BUELL
BYTES

COMPUTER GENERATED
TECHNICAL UPDATES & INFORMATION
FOR THE BUELL S2-THUNDERBOLT

ISSUE #1

MAY 1995

Parts Changes

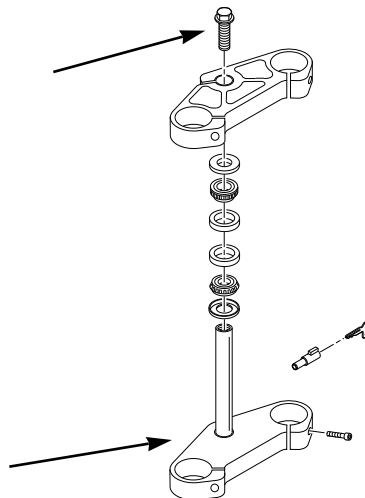
A change has been made, starting with vehicle # 817, to the lower triple tree and the bolt which secures the top triple tree.

<u>OLD</u>	<u>NEW</u>
triple clamp, lower	45506-94Y (solid I.D.)	45506-94YA (hollow I.D.)
bolt	45458-94Y (short)	45459-94Y (long)

New style triple trees can easily be identified by the hollow I.D. of the shaft and are a complete retrofit to all earlier vehicles. The late style, longer bolts **CANNOT** be used on early style solid triple trees.
